**FINAL
COMBINED ERRATA SHEET**

**GPA 16-01/ZCA 16-01/ZC 16-01/MP 14-01/LCPA 14-01/MCA 16-01
(DEV08014) – VILLAGE AND BARRIO MASTER PLAN**

The table below identifies all the final changes to the January 2018 Village and Barrio Master Plan as approved by the City Council on July 10, 2018. The table combines the revisions contained in the three errata sheets produced for the Planning Commission’s April 18, May 2, and May 16 meetings and in the fourth errata sheet prepared to reflect the Commission’s recommendations made at the May 16 meeting. It also includes Errata #5 and #6, presented to City Council at the July 10 meeting, and the amendments read into the approving motion to introduce Ordinance No. CS-335, presented as Exhibit 3 to the City Council staff report.

Combined Errata, Exhibit 2

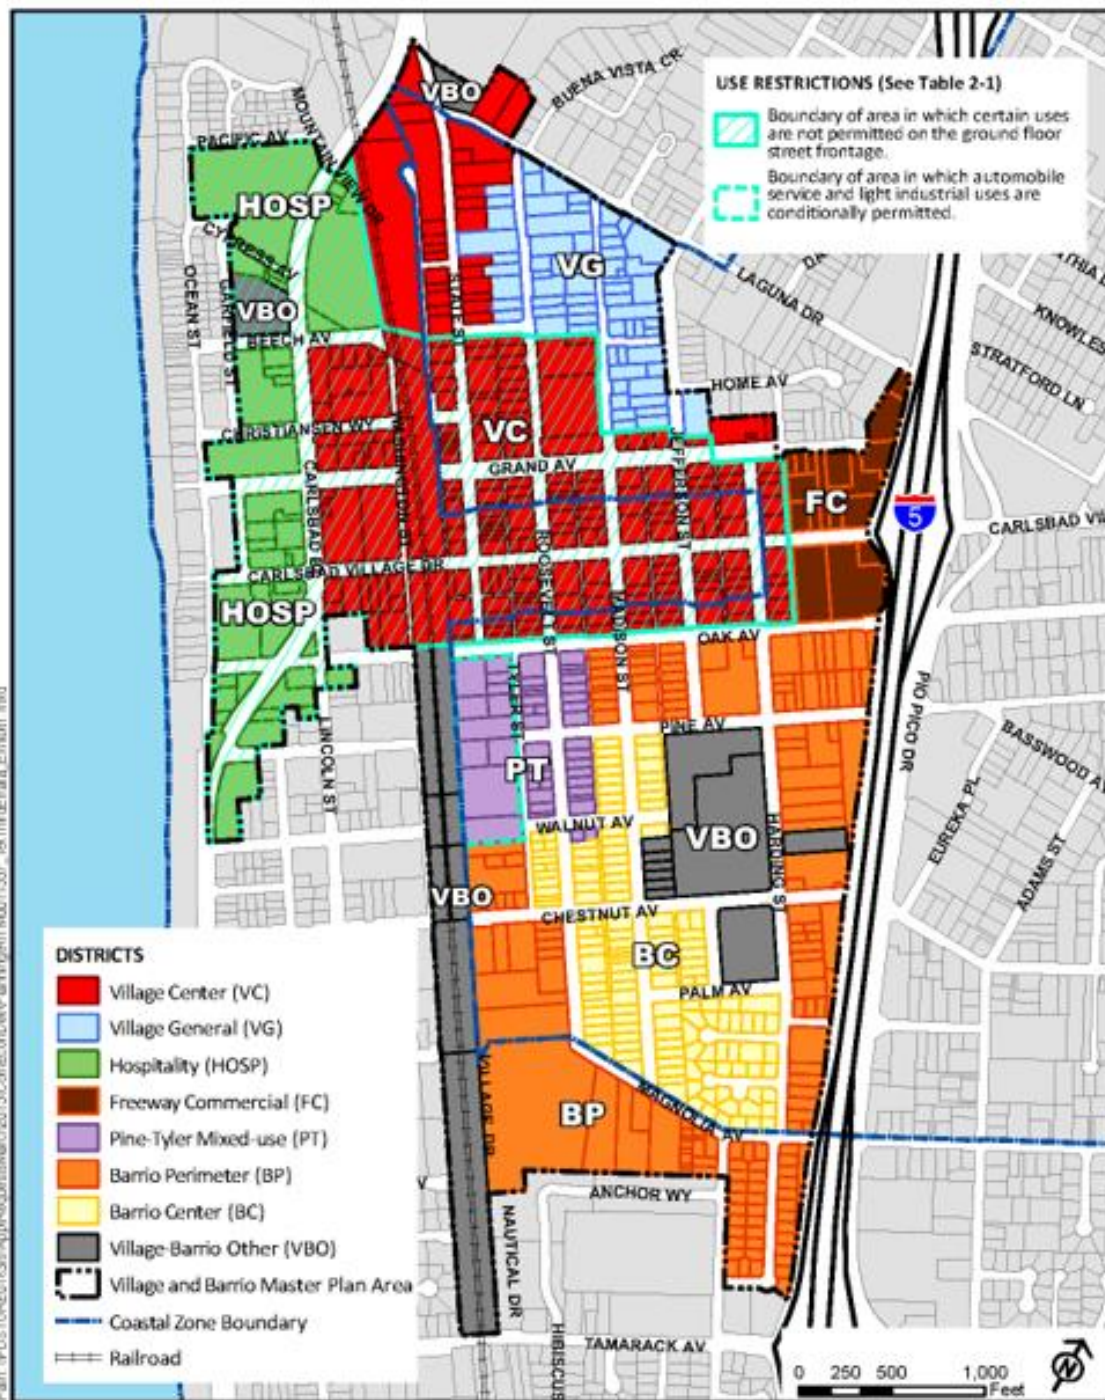
NOTE: Exhibit 2 incorrectly shows the proposed districting for a parcel (APN 203-101-22) between State and Roosevelt Streets and north of Beech Avenue. The exhibit shows the parcel as being entirely within the VG District. Consistent with Figure 2-1 of the proposed plan, the parcel should be split by the VC and VG districts. See below.
